ECE/TRANS/WP.29/GRSG/2007/14  
1 February 2007

Regulation No. 46 (Devices for indirect vision)

Proposal for draft amendments to Regulation No. 46

Submitted by the expert from the International Motorcycle Manufacturers Association

**Figure 1a: Example of rear-view mirror bending-test rig"**

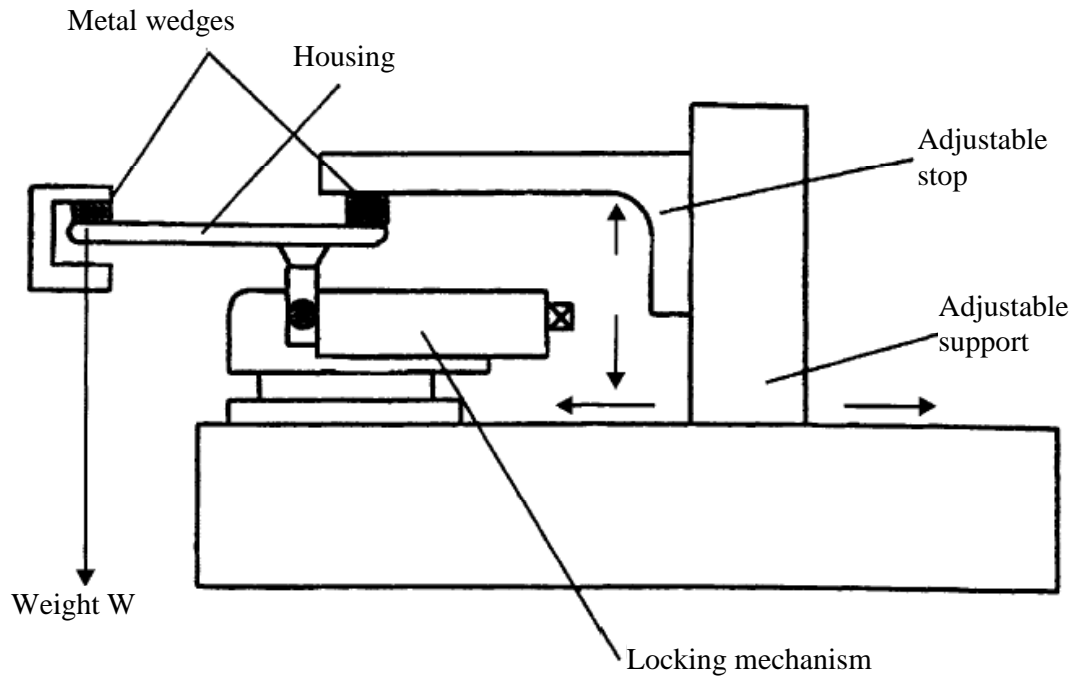
**6.1.3.3. Bending test on the protective housing attached to the stem (Class VII)**

The protective housing is placed horizontally in a device in such a way that it is possible to lock the attachment support adjusters firmly. In the direction of the largest dimension of the housing, the end closest to the point of attachment on the adjuster for the support shall be immobilized by a 15 mm-wide rigid stop covering the entire width of the housing.

At the other end, a stop identical to the one described above is placed on the housing so that the specified test load can be applied to it (Figure 1a).

The end of the housing opposite to that where the force is exerted may be locked rather than held in position as shown in Figure 1a.

**6.1.3.3.2.** The test loading shall be 25 kilograms and shall be maintained for one minute.

**Figure 8a**

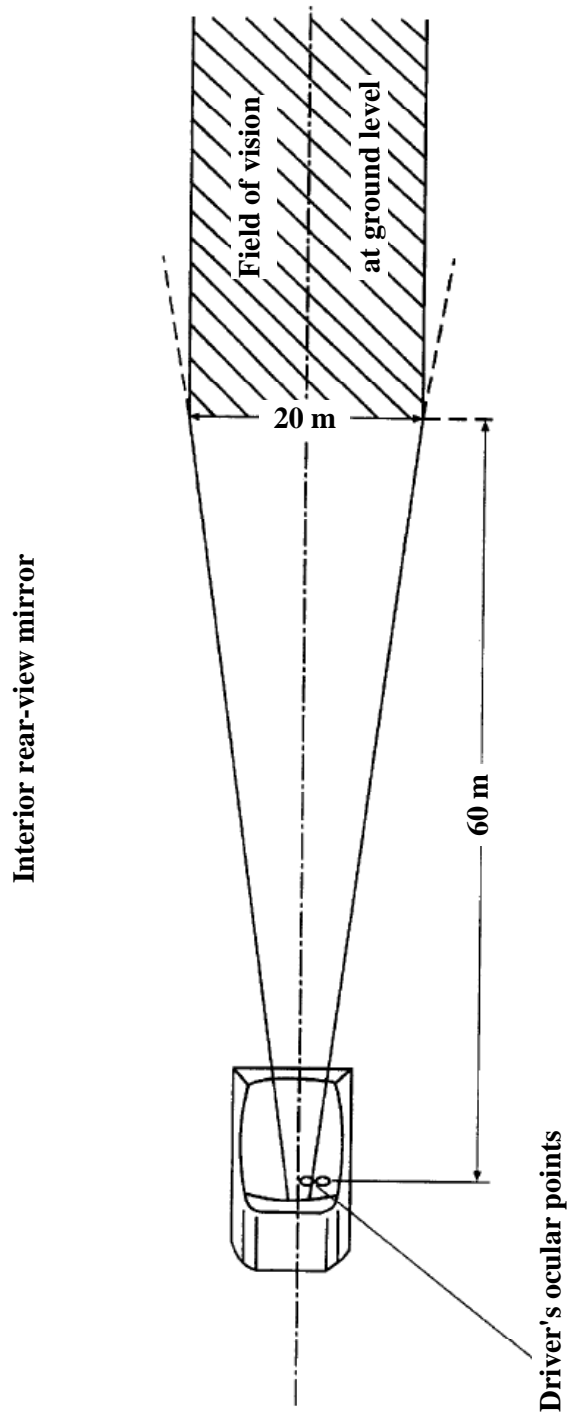
**Interior rear-view mirror (Class I)**

The field of vision must be such that the driver can see at least a 20 m wide, flat, horizontal portion of the road centred on the vertical longitudinal median plane of the vehicle and extending from 60 m behind the driver's ocular points (Figure 8a) to the horizon.

Figure 8b''

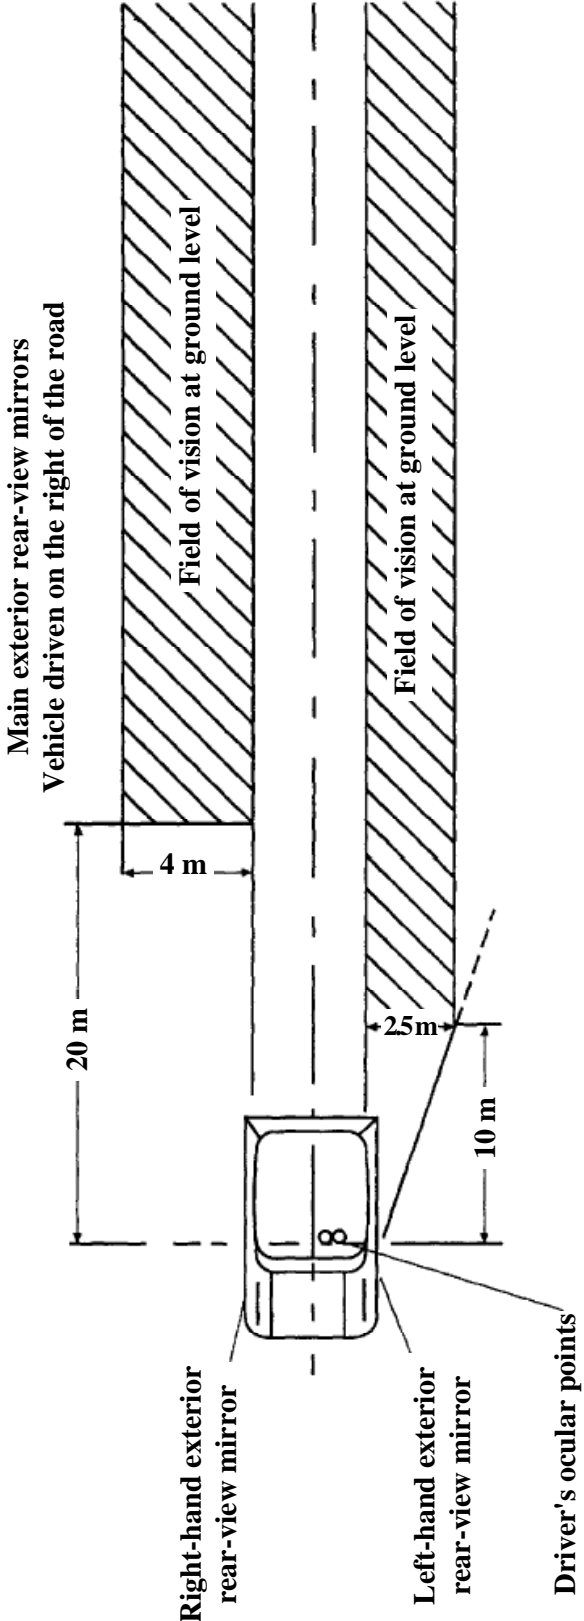
**15.3.4.2.1. Left-hand exterior rear-view mirror for vehicles driven on the right of the road and right-hand exterior rear-view mirror for vehicles driven on the left of the road.**

The field of vision must be such that the driver can see at least a 2.50 m wide, flat, horizontal portion of the road, which is bounded on the right (in the case of vehicles driven on the right), or on the left (in the case of vehicles driven on the left) by the plane which is parallel to the median longitudinal vertical plane passing through the outermost point of the vehicle on the left (in the case of vehicles driven on the right), or on the right (in the case of vehicles driven on the left) and extends from 10 m behind the driver's ocular points to the horizon (Figure 8b).

**15.3.4.2.2. Right-hand exterior rear-view mirror for vehicles driven on the right and left-hand exterior rear-view mirror for vehicles driven on the left.**

The field of vision must be such that the driver can see at least a 4 m wide, flat, horizontal portion of the road which is bounded on the left (in the case of vehicles driven on the right), or on the right (in the case of vehicles driven on the left) by a plane parallel to the median longitudinal vertical plane passing through the outermost point of the vehicle on the right (in the case of vehicles driven on the right) or on the left (in the case of vehicles driven on the left) and which extends from 20 m behind the driver's ocular points to the horizon (Figure 8b).
